**Economic and Social Council**Distr.: General
23 November 2015

Economic Commission for Europe**Inland Transport Committee****World Forum for Harmonization of Vehicle Regulations****Working Party on Brakes and Running Gear****Eighty-first session**

Regulation No. 90 (Replacement brake linings)**Proposal for a Supplement to the 02 series of amendments
to Regulation No. 90 (Replacement brake linings)****Submitted by the experts from Italy***

Figure 1

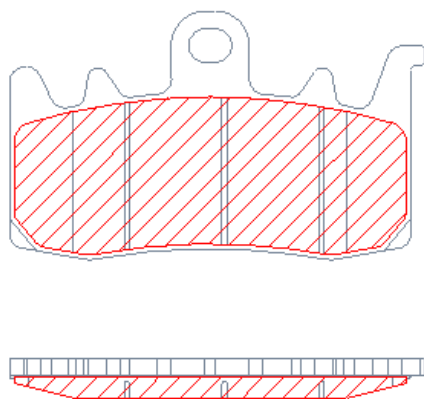
Friction material area means all the area enclosed within the perimeter of the brake lining (see the red cross-hatched area, Figure 1), thus excluding the presence of any grooves and/or chamfers:
